STERLING RANCH FILING NO.2

STORM SEWER PLANS

APRIL 2021

SF-20-015

**POND W4 EMERGENCY SPILLWAY4
STA 0+00.00 TO 5+00.00
PRIVATE (SRMD)**

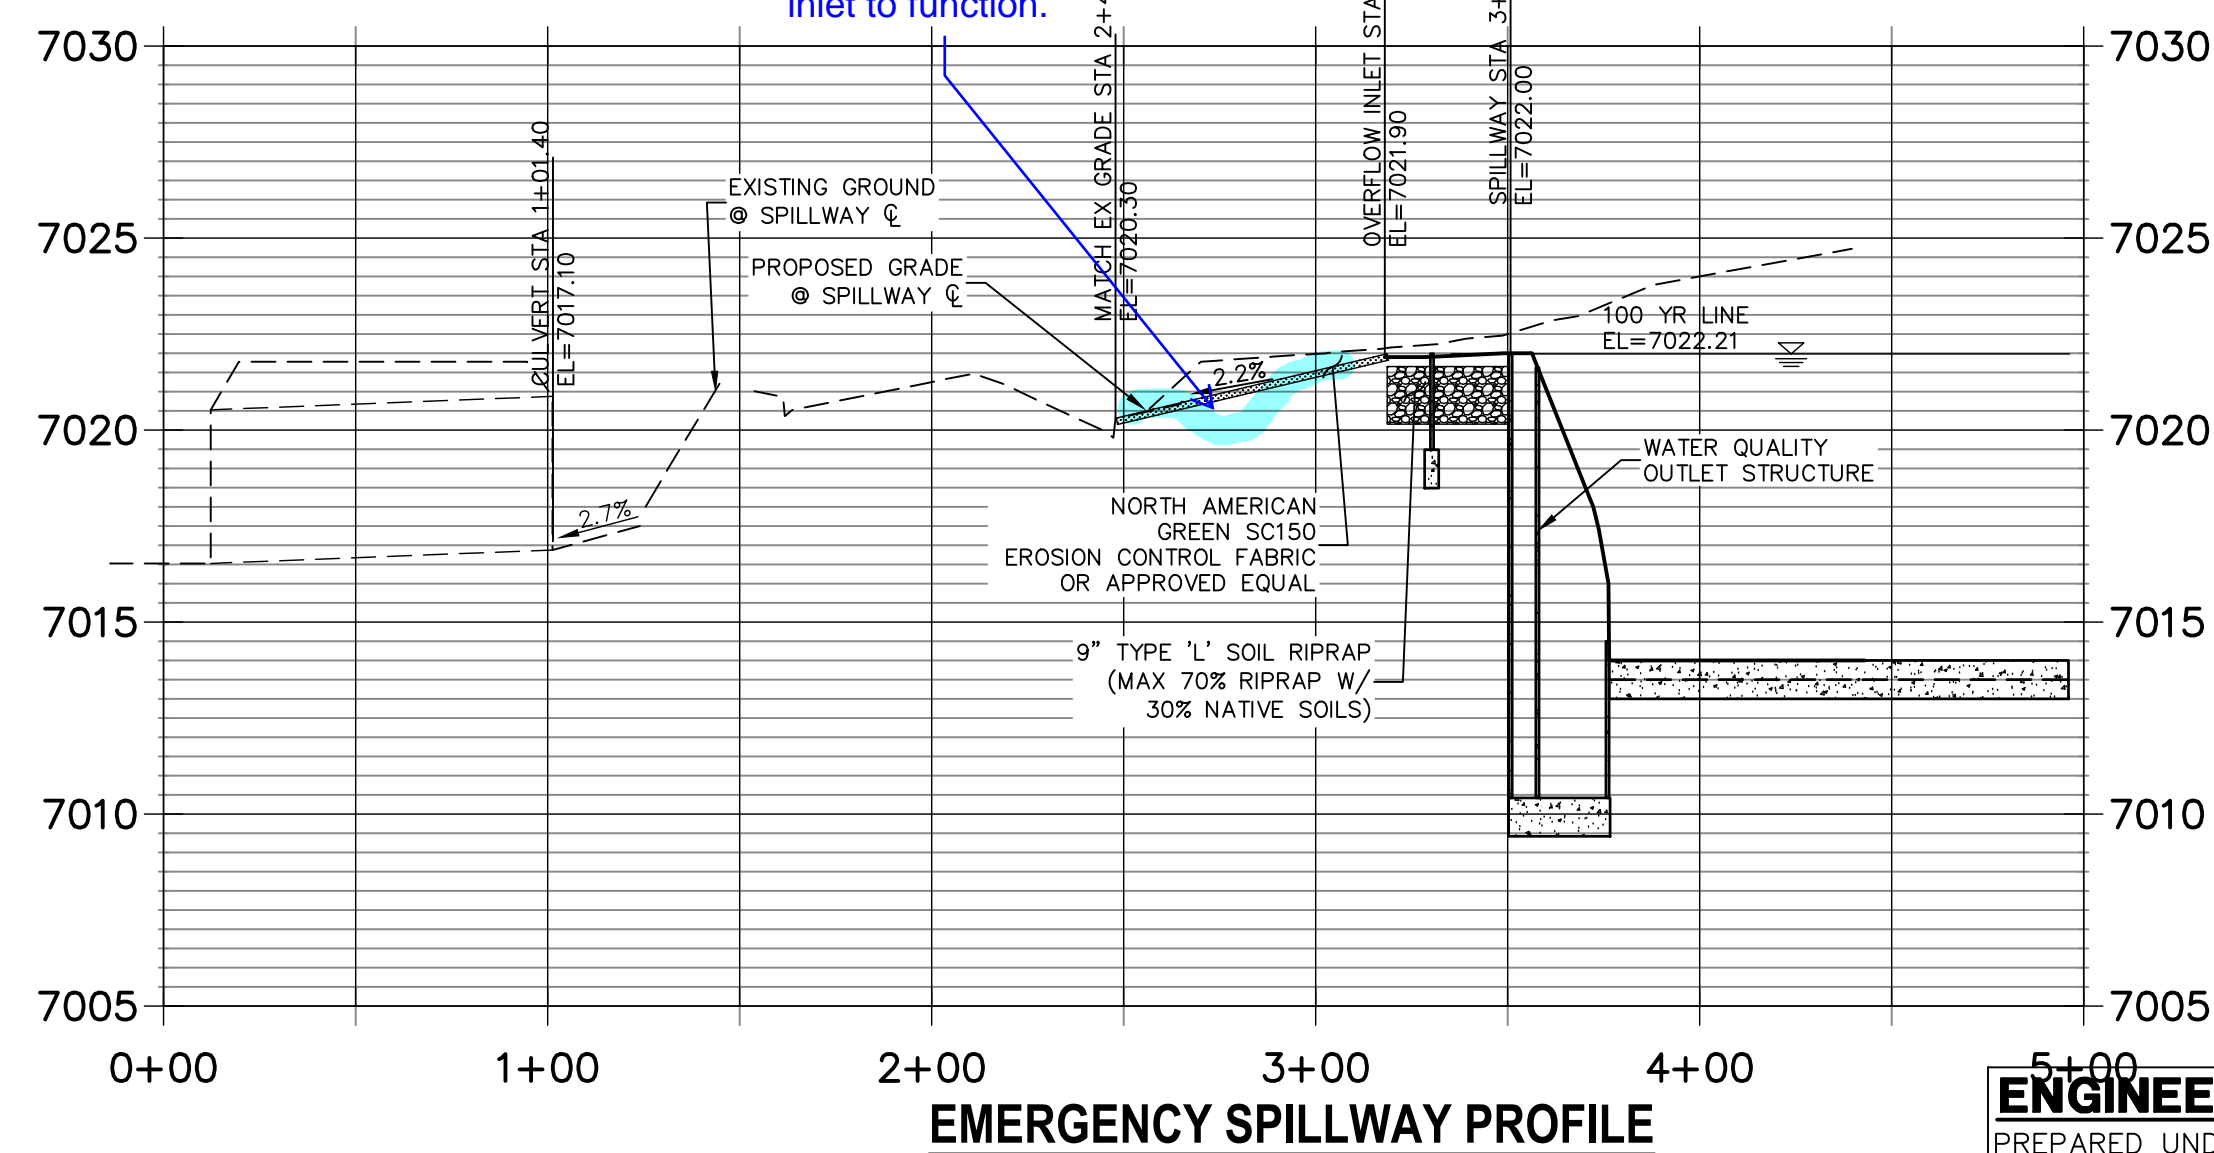
There needs to be a low spot for the inlet to function.
